LPP #45M 0018A

TOLERANCES (UNLESS OTHERWISE NOTED)	TITLE	MATERIAL
FRACTIONS ± 1/64	MODIFICATIONS TO ALLOW	
DECIMAL xx ± .002	DRYER TO FIT #9 - #5 PM	DRAWING NO.
xxx ± .005	DATE 7-18-80	40-M-224
ANGULAR ± 30'	SCALE 1/4" = 1"	DRAWN BY C. STEWART

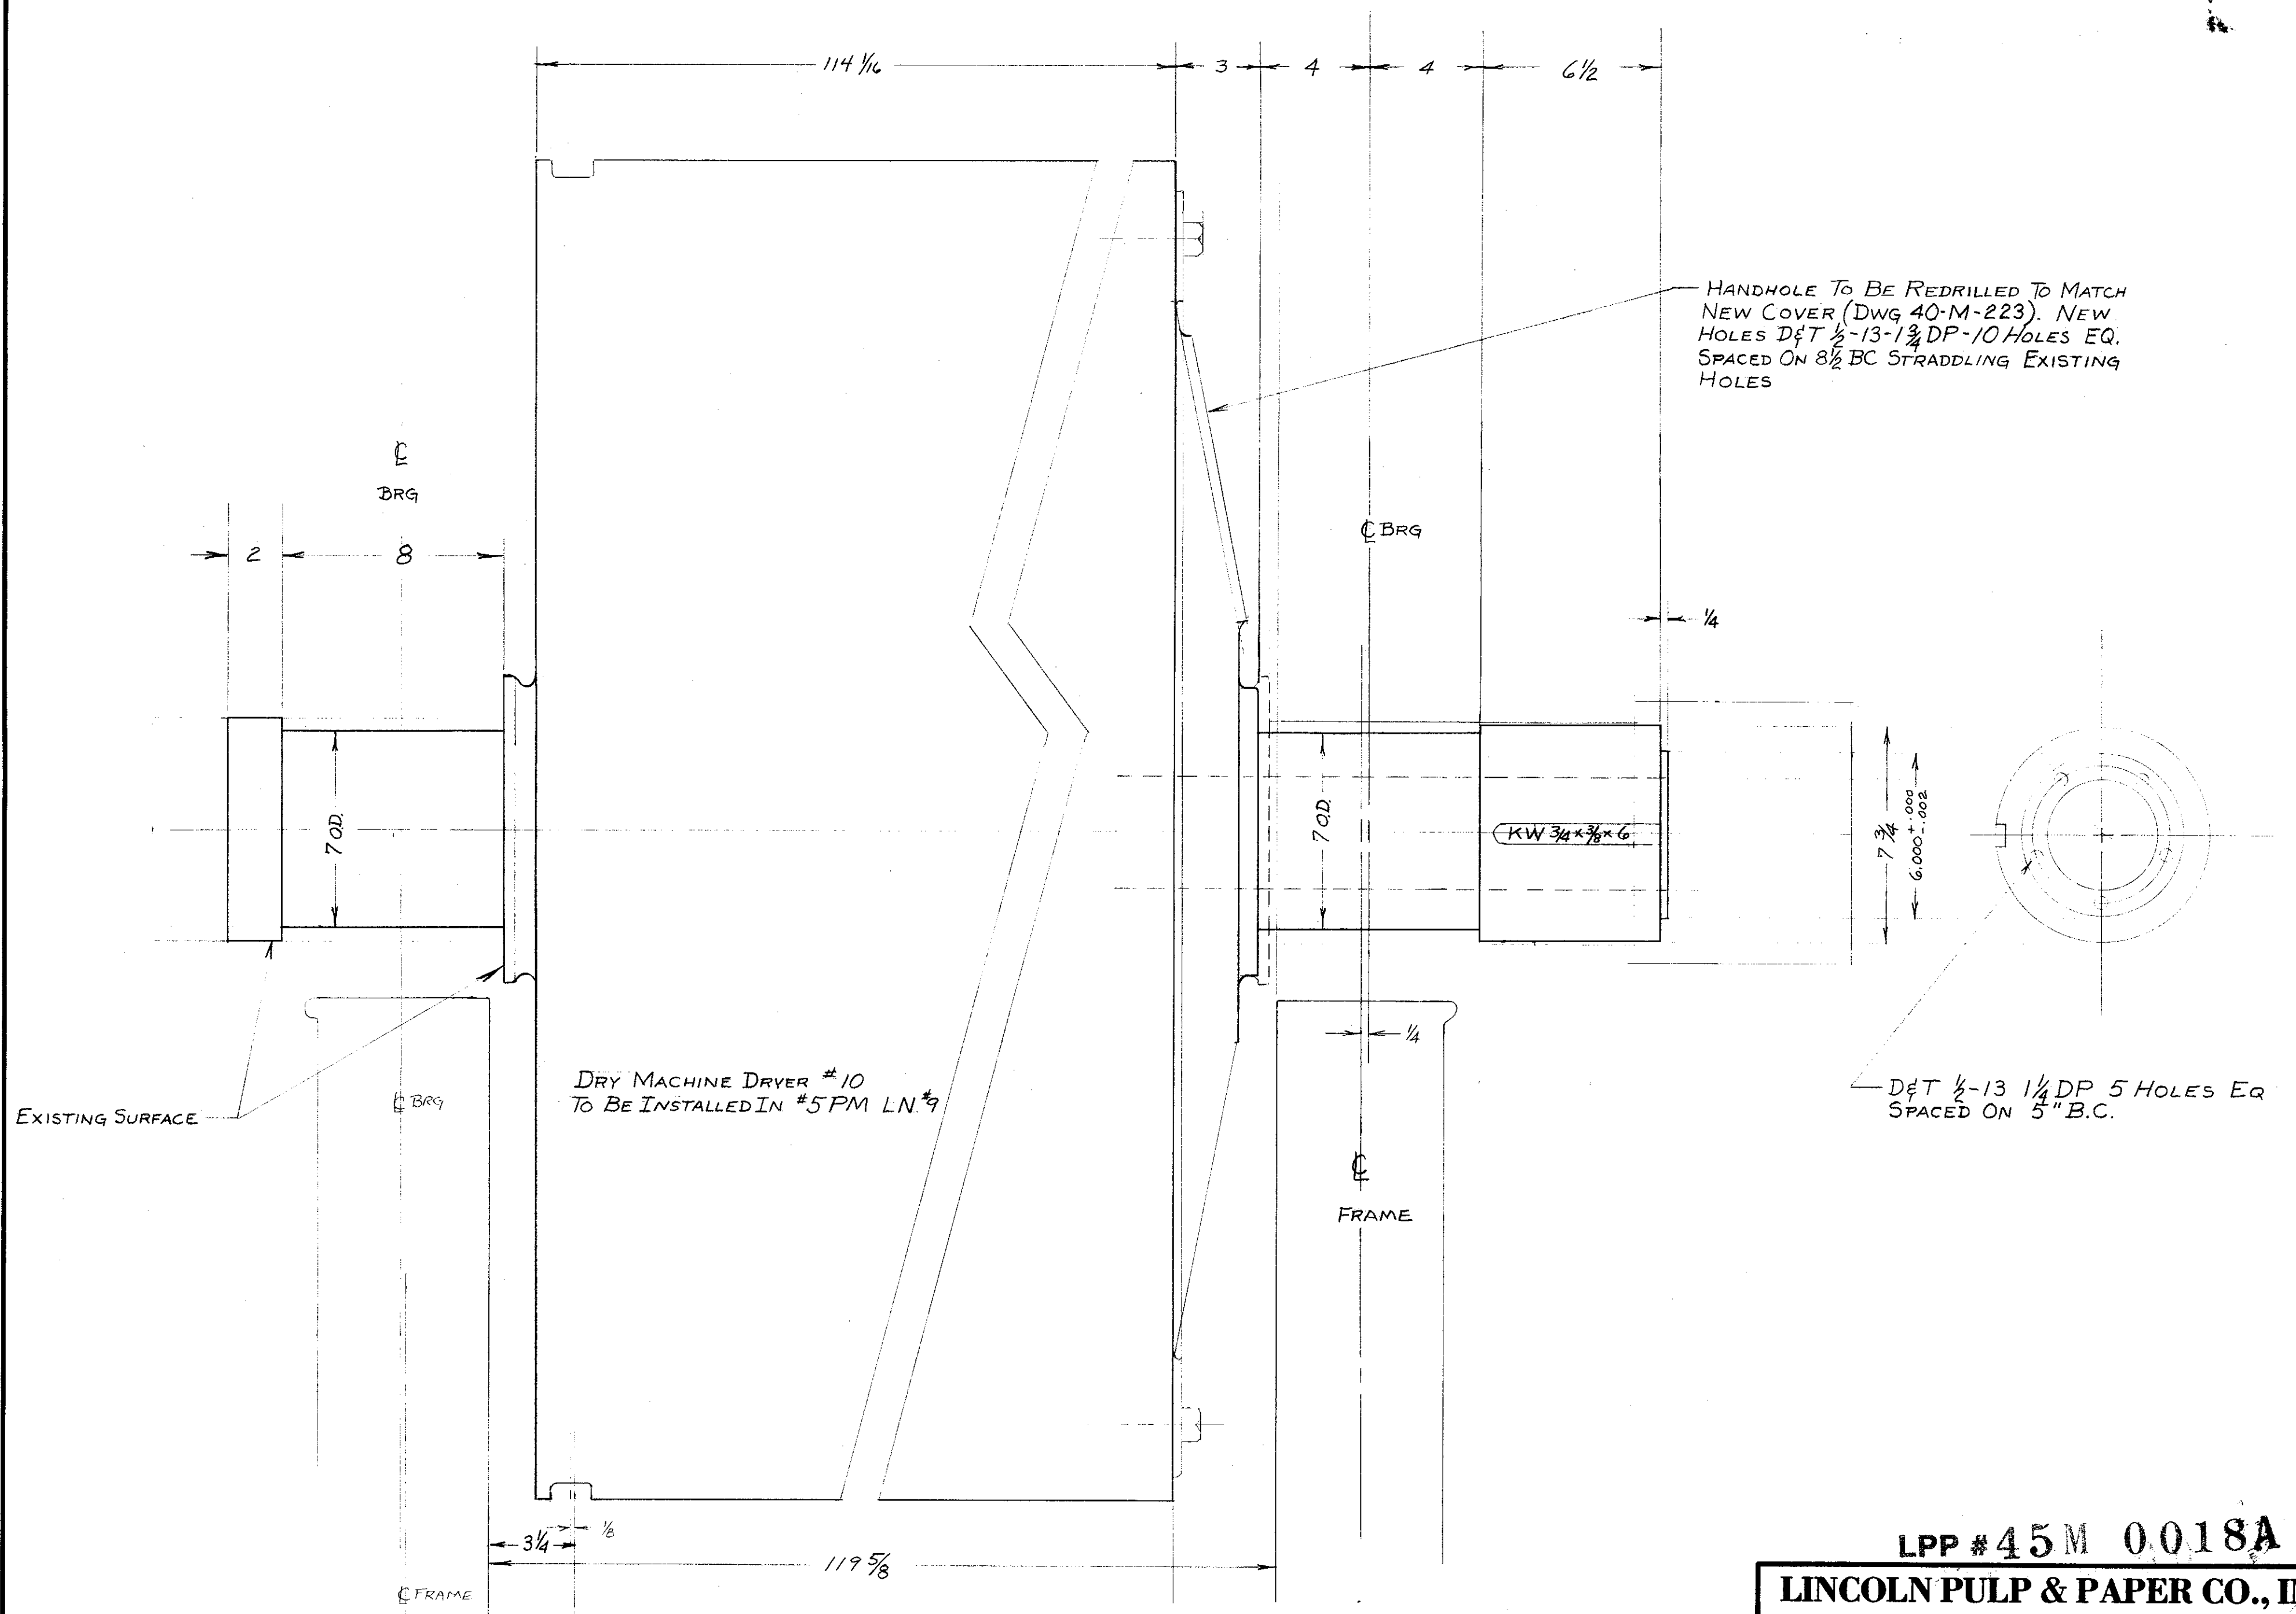
HANDHOLE TO BE REDRILLED TO MATCH
NEW COVER (DWG 40-M-223). NEW
HOLES DET 1/2-13-1 3/4 DP-10 HOLES EQ.
SPACED ON 8 1/2 BC STRADDLING EXISTING
HOLES

DRY MACHINE DRYER #10
TO BE INSTALLED IN #5 PM LN #9

DET 1/2-13 1/4 DP 5 HOLES EQ
SPACED ON 5" B.C.
